**Assembly Title 21 Committee
August 9, 2012**

**Response to Planning and Zoning Commission Recommended
Amendments to the Provisionally Adopted Title 21**

Date: August 9, 2012
To: Assembly Title 21 Committee
From:  Jerry T. Weaver, Jr., Director
Subject: Review of PZC Recommended Amendments to Provisionally Adopted Chapter 8

West Park Subdivision—
full layout plan

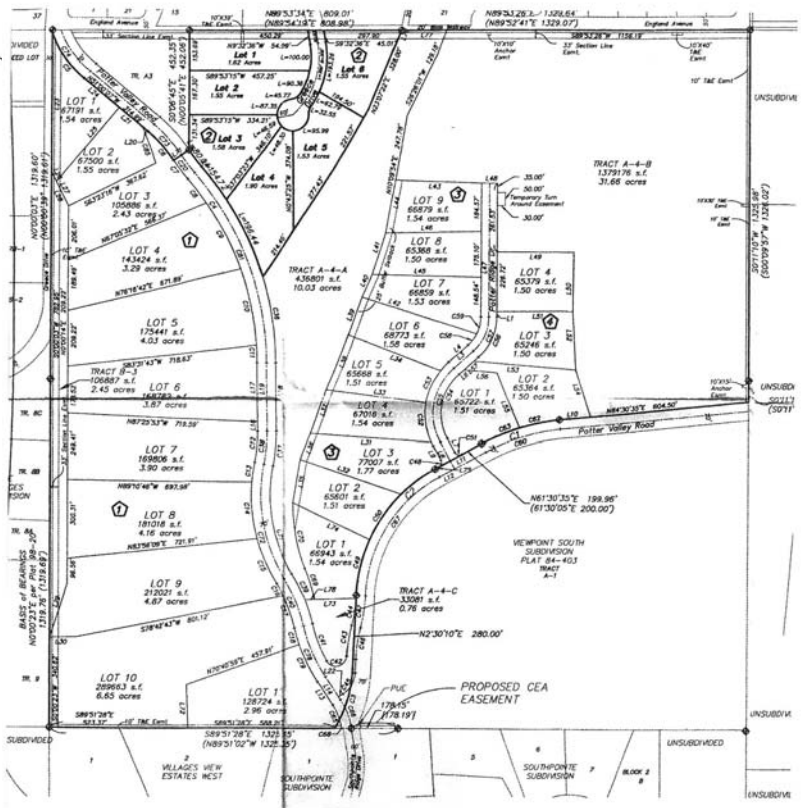
- Phased projects tend to be large scale developments, which can take more than many years to complete. See (1).
- Currently, where there is an approved full layout plan, all of the phases are reviewed for compliance with the conditions of approval the full layout plan, which can be valid for up to ten years. The conditions of the full layout plan arise from the code that was in place at the time it was approved. The phases are reviewed against those conditions, not against whatever code is current at the time each phase is submitted. If a later phase does not conform to the full layout plan (e.g., a school site is now proposed where residential lots were shown in the full layout plan), this phase would be reviewed anew under the regulations in place at the time of the phase’s submittal.

1. For large parcels with an approved full layout plan, future phases should be reviewed for compliance with the full layout plan. The Department does not object to a second five-year extension of the approval, through a series of 18 month approvals, not to exceed 60 months, allowing the full layout plan to be in place for a maximum of 15 years, which is five years longer than the current Title 21.
2. If no full layout plan is submitted, each phase of the development should be reviewed under the Title 21 in place at the time the application is submitted.

Potter Highlands Subdivision—
example of tracts without a full
layout plan

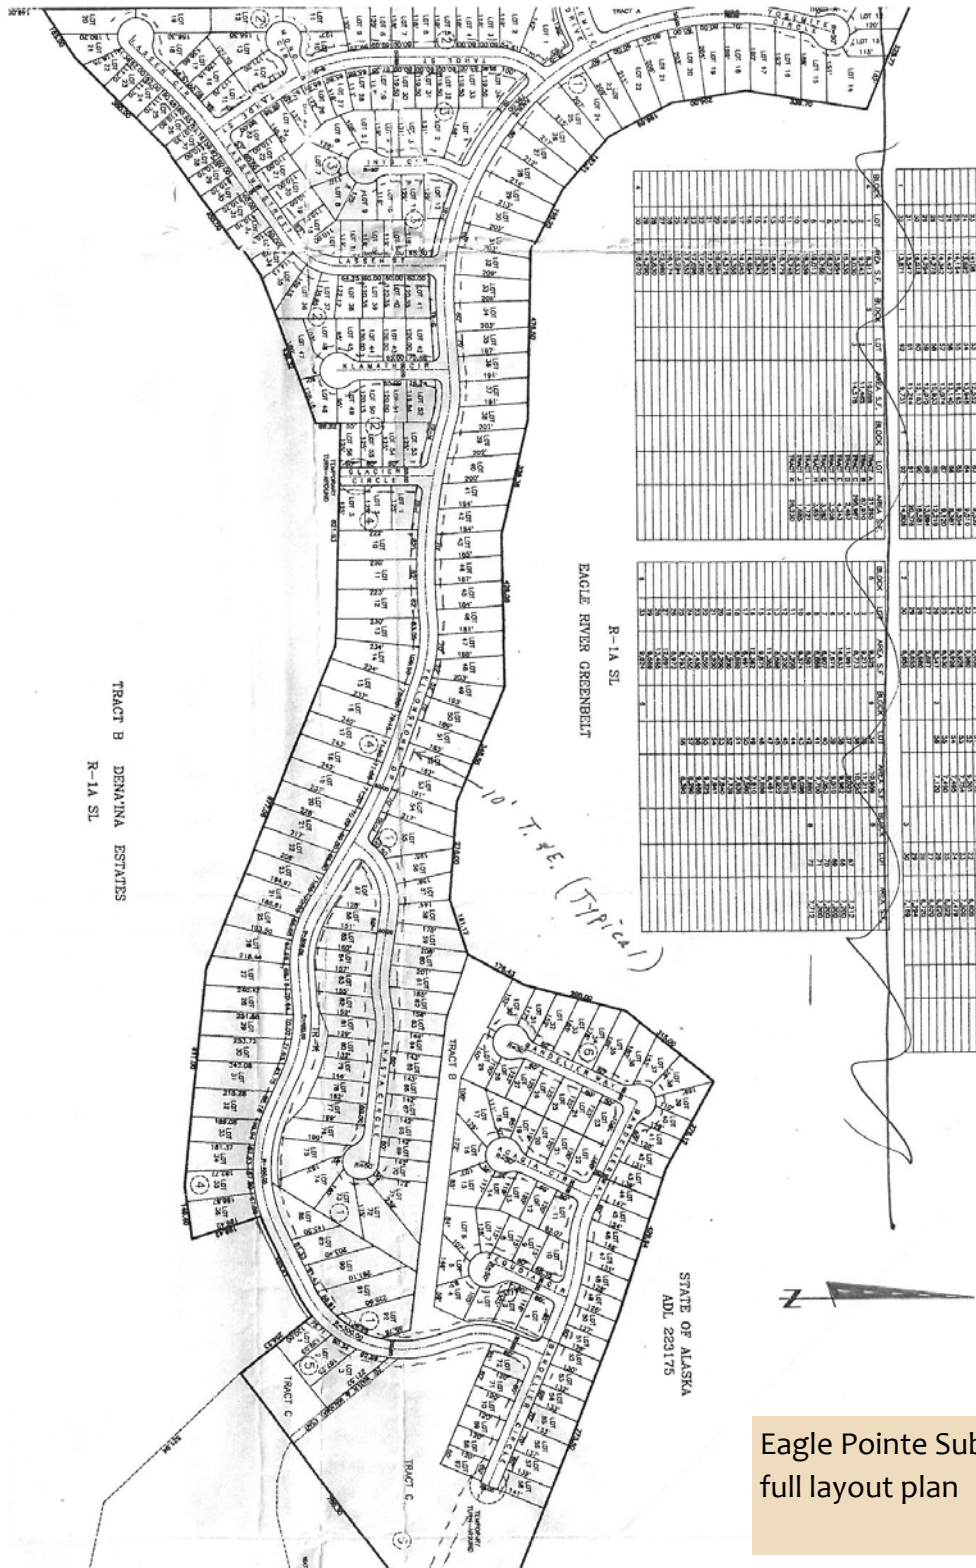
- Where there is no full layout plan, and the land is tracted out with no indication of future development plans, it would be inappropriate for future phases to be reviewed to the code in place when the first phase was approved. People do not have vested development rights to use the design standards of the code in place when the land was tracted out, if the simply tract out a property and do not submit a layout plan for review and approval. The MOA does not know what is being proposed.
